# PREVOST

## WARRANTY BULLETIN

Wb08-07

| SUBJECT : IMPROVED AIR CIRCULATION ON H3 COACHES<br>EQUIPPED WITH WCL AND SLIDING DOOR |           |           |

FIGURE 1

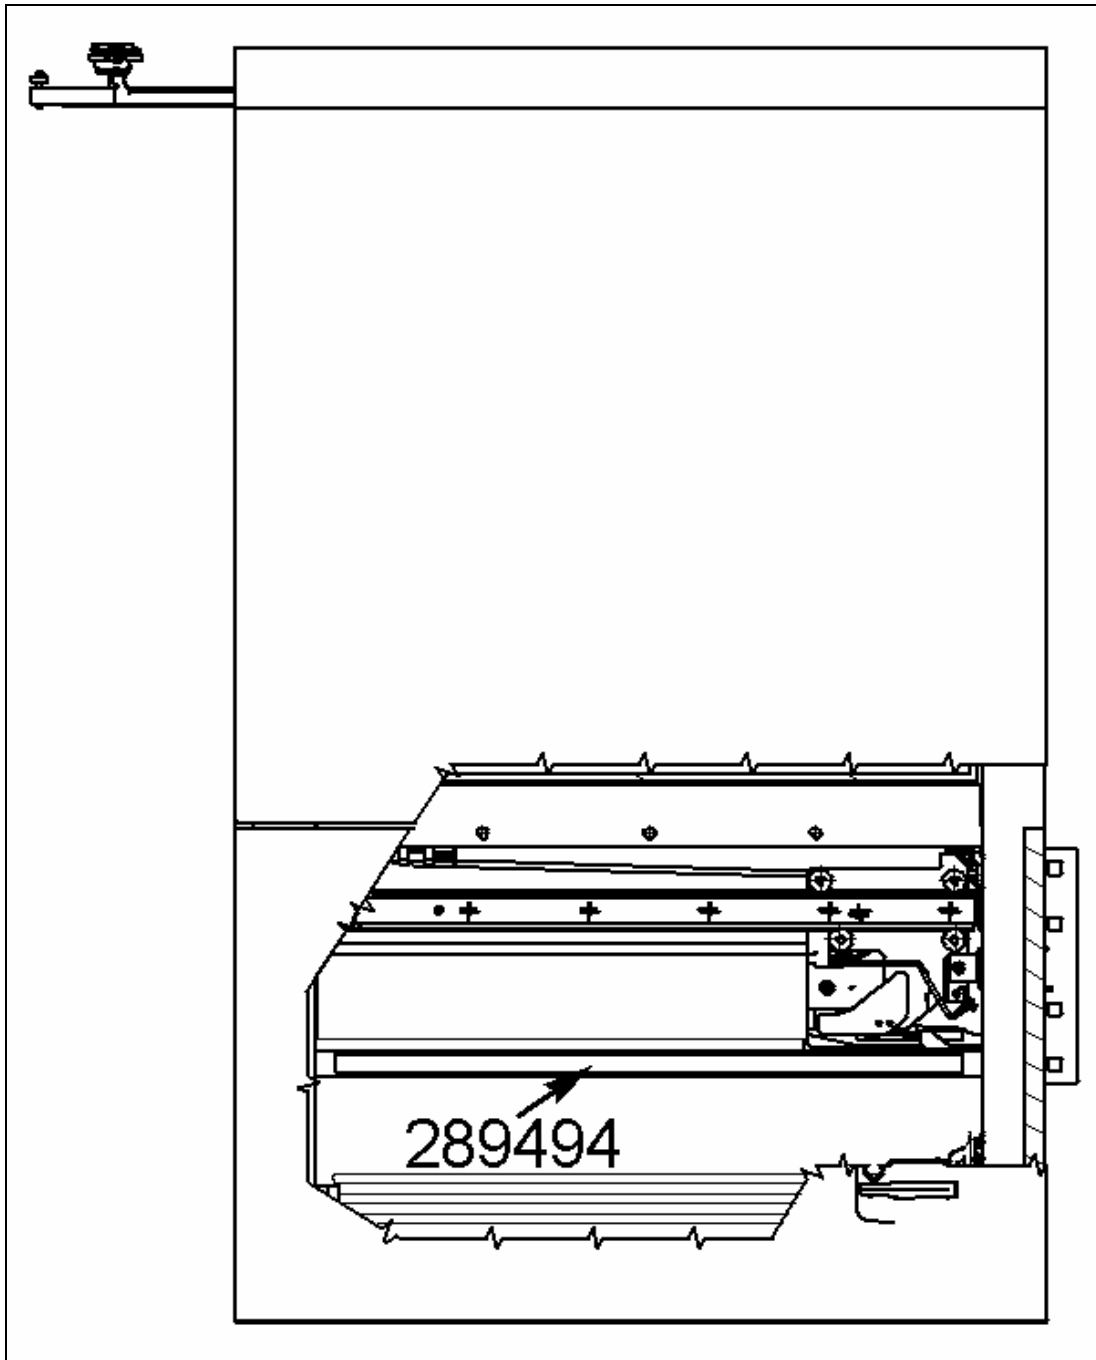
- 1) Remove the existing door air ducting front and rear end parts. Also remove the door air ducting assembly.
- 2) Affix the air ducting assembly insulating part (289494) onto the air ducting assembly (329611) (Refer to figure 1).

FIGURE 4

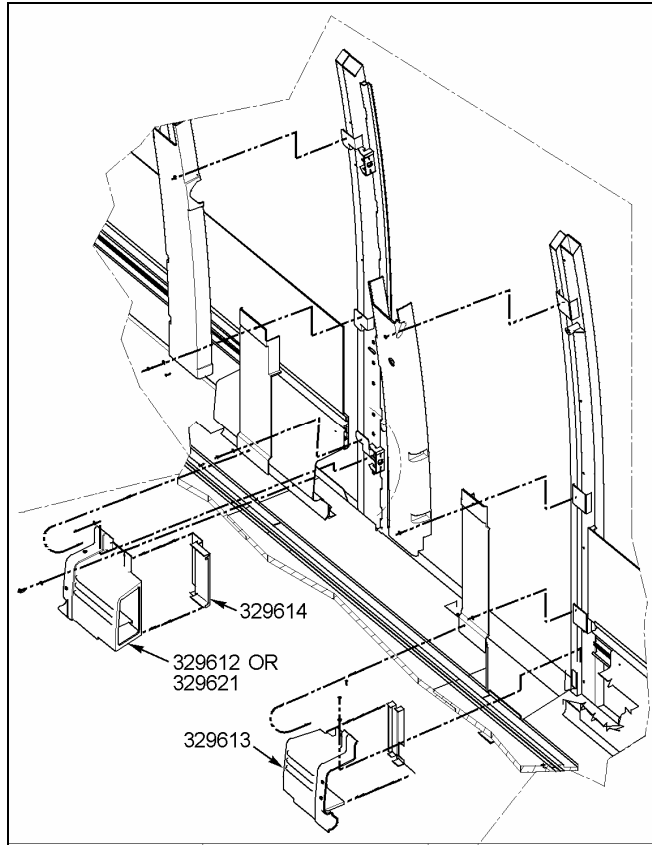
- 4) Fix the air ducting closing part (329614) onto the air ducting front end part (329612 or 329621) then install the air ducting front end part (Refer to figure 4).

- 5) Install air ducting rear end part (329613) (Refer to figure 4).
- 6) Fix front wall insulating part (506264) behind the extrusion as indicated in figure 5.

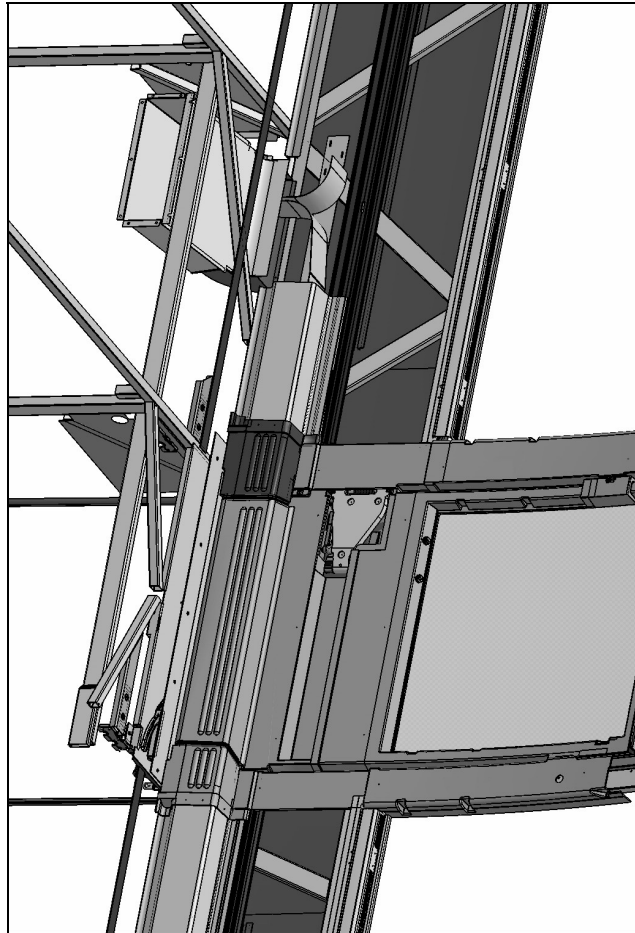
After you remove the existing deflector, install the “new” deflector with a longer rearward wing.

*It seems to be easier to remove the seat in front of the deflector to gain access to the opening. It also seems easier to install the new deflector with the seat removed.*
